HISTORIC PRESERVATION BOARD

HISTORIC PRESERVATION BOARD MEETING

PUBLIC HEARING
144 STATE STREET (Winter Street frontage)

TO: Chair Pollard and Members of the Historic Preservation Board
FROM: Deborah Andrews, Historic Preservation Program Manager
Rob Wiener, Preservation Compliance Coordinator
DATE: June 11, 2021
RE: June 16, 2021 PUBLIC HEARING – Final Review of Proposed New
Construction – Application: HPBR-001408

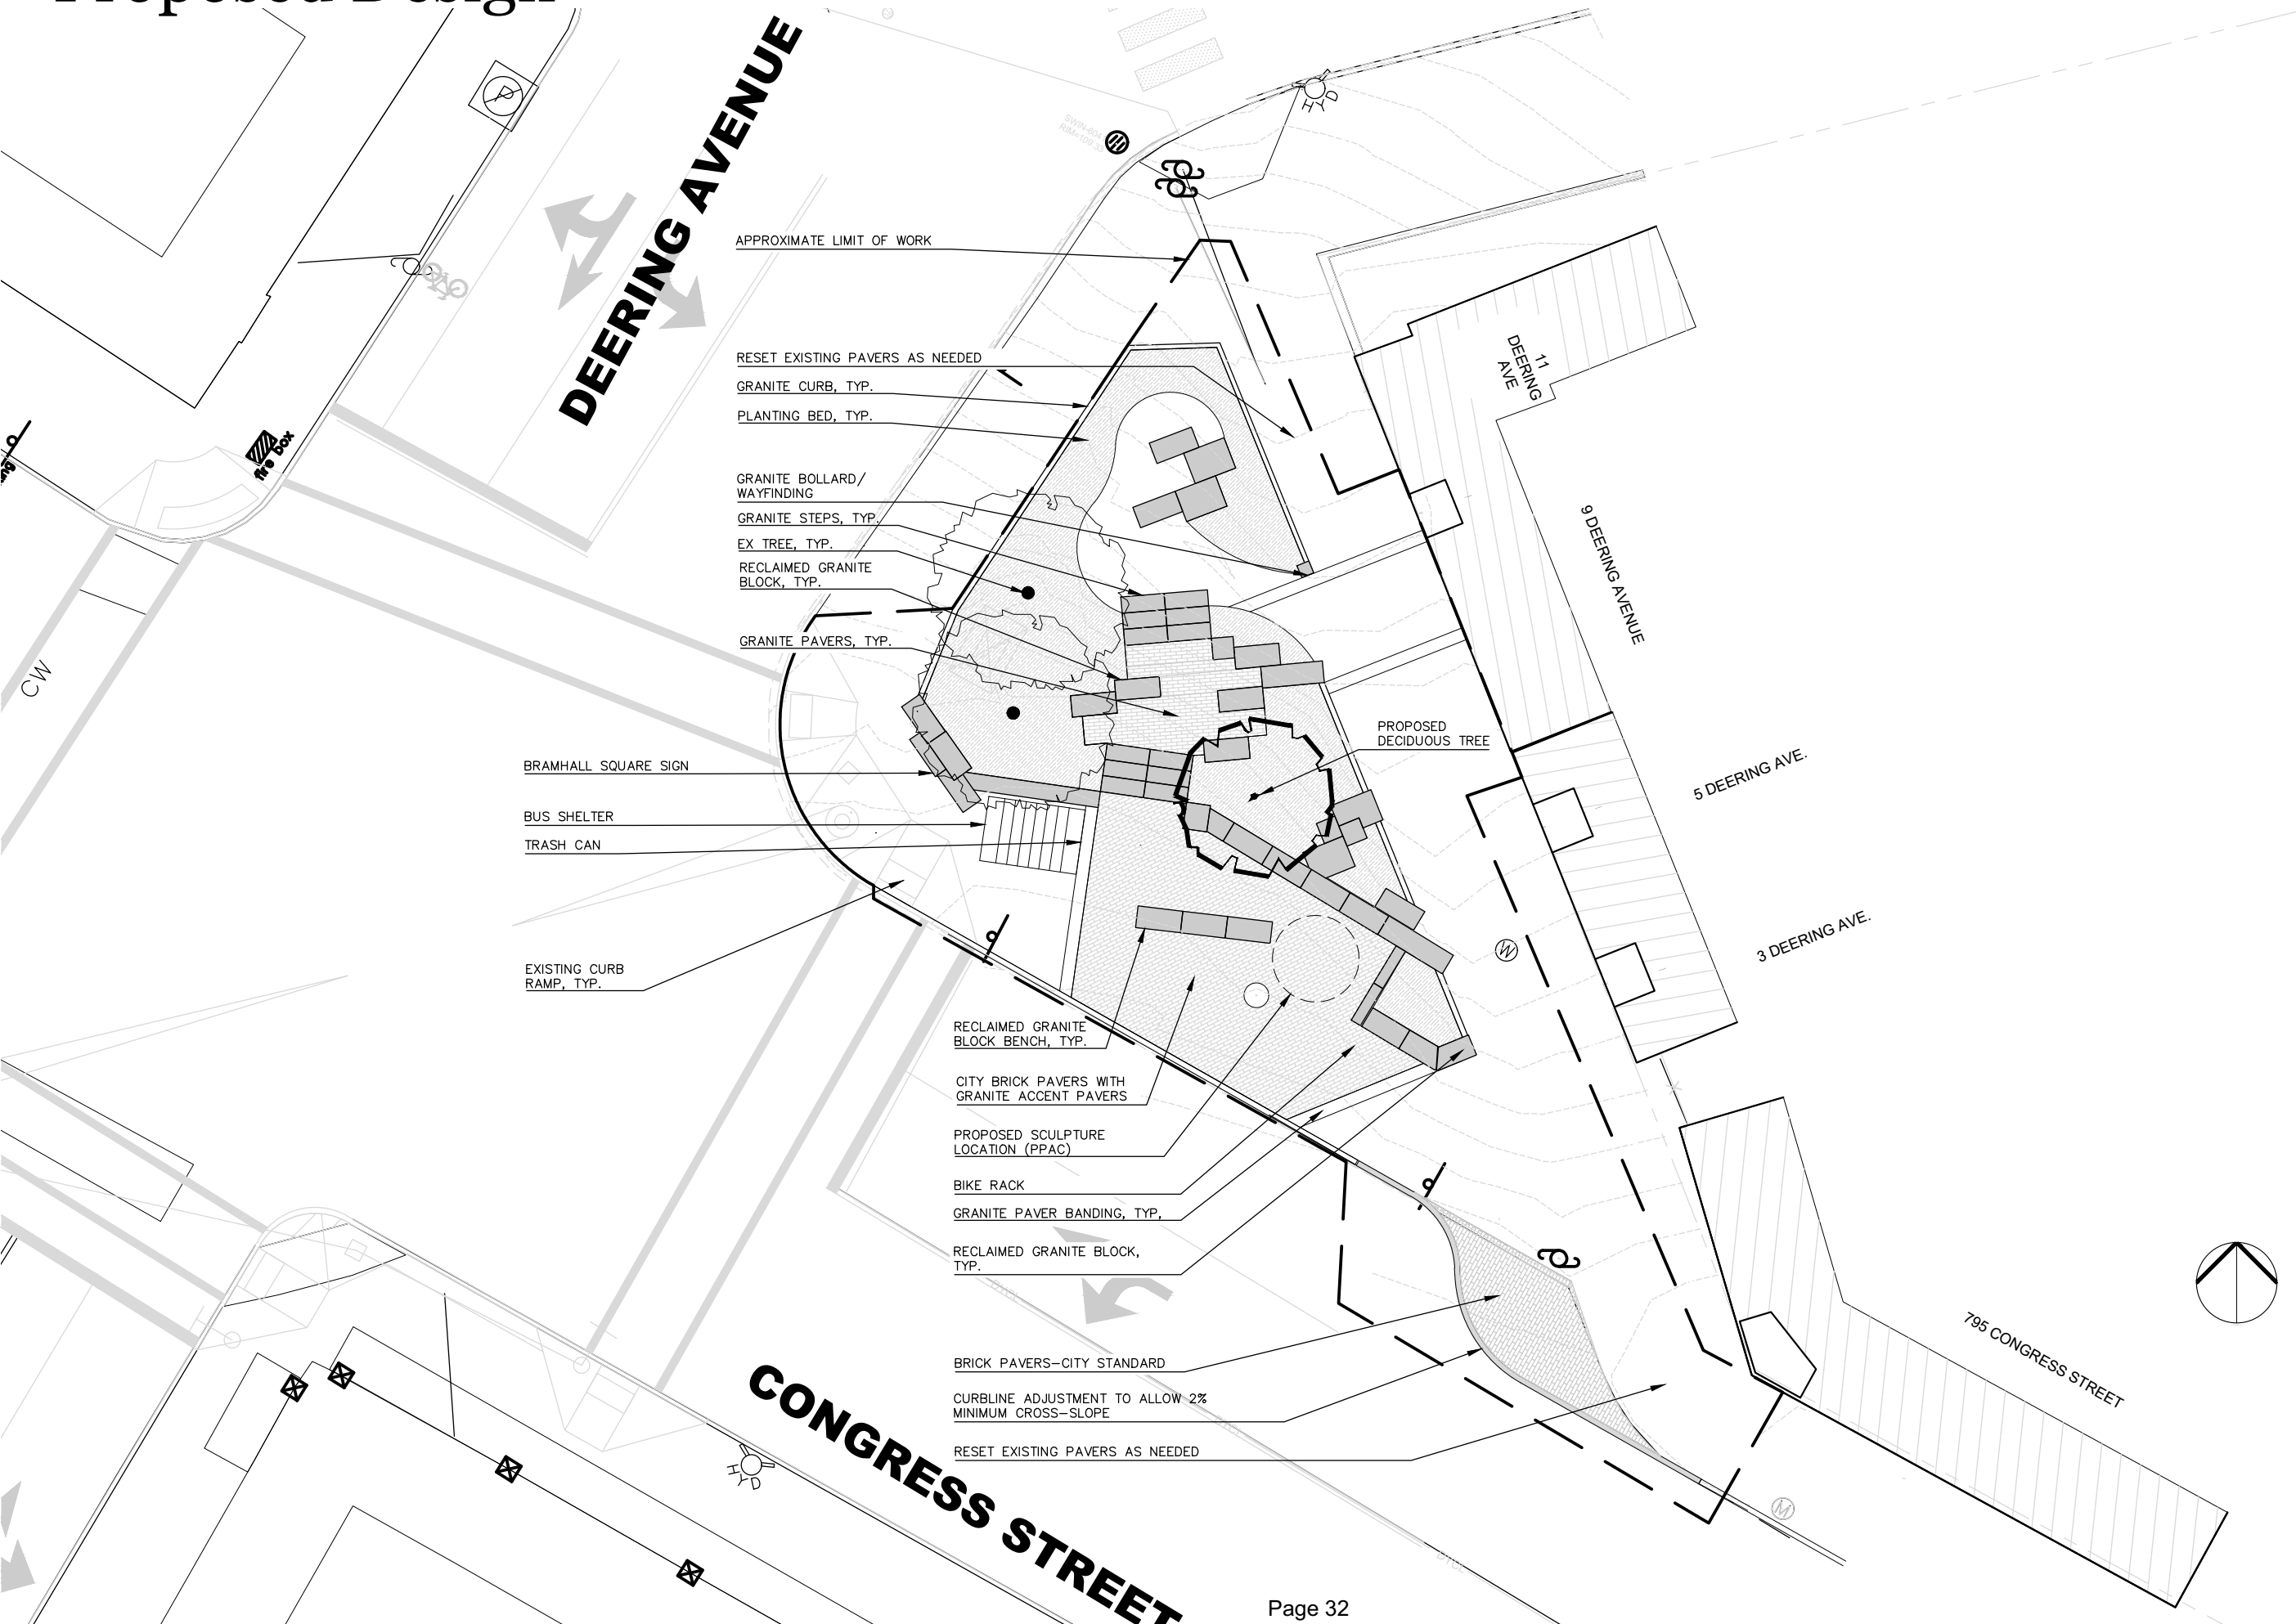
In staff's view, the design for the square has been significantly improved with the various modifications made since the January workshop. The treatment is simpler, more straightforward and cohesive. The use of granite is more sparing and judicious. The move to separate the shelter from the balance of the square not only alleviates some of the visual clutter that was a concern with the original proposal, but also separates the functions. The elimination of the sign also simplifies the treatment. And the frank expression of stormwater treatment as an integral part of the square's design is highly appropriate. The proposed material palette, particularly the incorporation of granite, serves to relate this square to the surrounding context.

Regarding the stakeholders' desire to add public art to the square, staff recommends that consideration be given to commissioning a custom bus shelter for this location and have the shelter serve as the public art. The shelter will be, by necessity, a prominent fixture at this intersection and provides an obvious opportunity for a creative design solution. This approach would also keep the number of elements within this small space limited and avoid competing elements.
